HN-236  
DN-184  
EN-77  
FN-63  
NN-005

# SERVICE BULLETIN

DATE: 10 MARCH 1994

## FOUR-WAY TRIM SWITCH REPLACEMENT PROGRAM

**Figure 1. Four-way Trim Switch.**

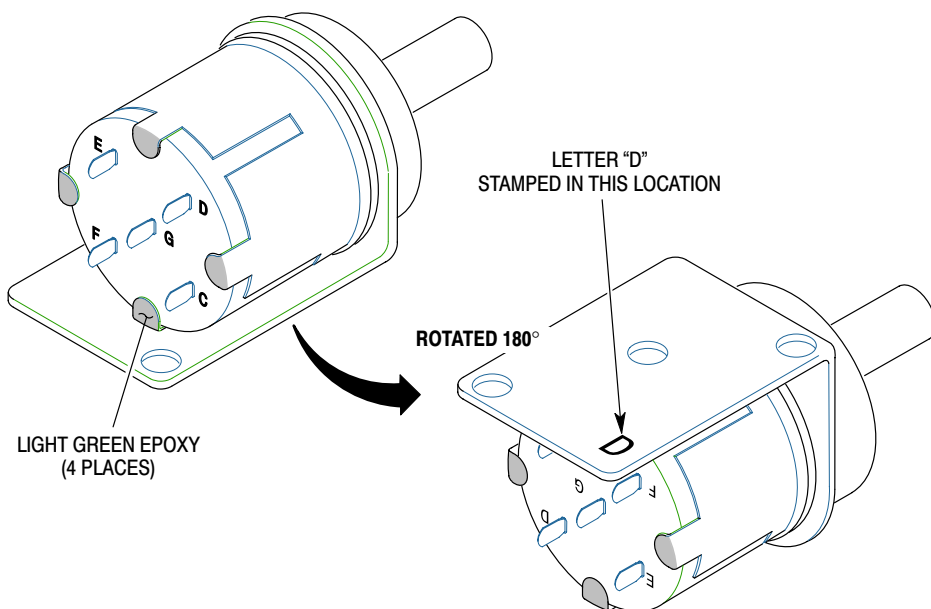
Procedures in this notice require operators to replace affected four-way trim switches with switches that have been upgraded by Guardian to a Rev. "D" configuration. Upgraded A218-100646-03 switches can be readily identified by the green colored epoxy added to the four tabs at the bottom of the switch and Rev. "D" stamped on the bottom of the mounting bracket of the switch (see Figure 1).

- (1). Remove affected A218-100646-03 switches per instructions contained in the Handbook of Maintenance Instructions (CSP-HMI-2).
- (2). Install an A218-100646-03, marked with Rev. "D" on its mounting bracket, per instructions contained in the Handbook of Maintenance Instructions (CSP-HMI-2). **NOTE:** A218-100646-03 switches marked with Rev. "D" will also have green epoxy over the four tabs at the base of the switch (see Figure 1).
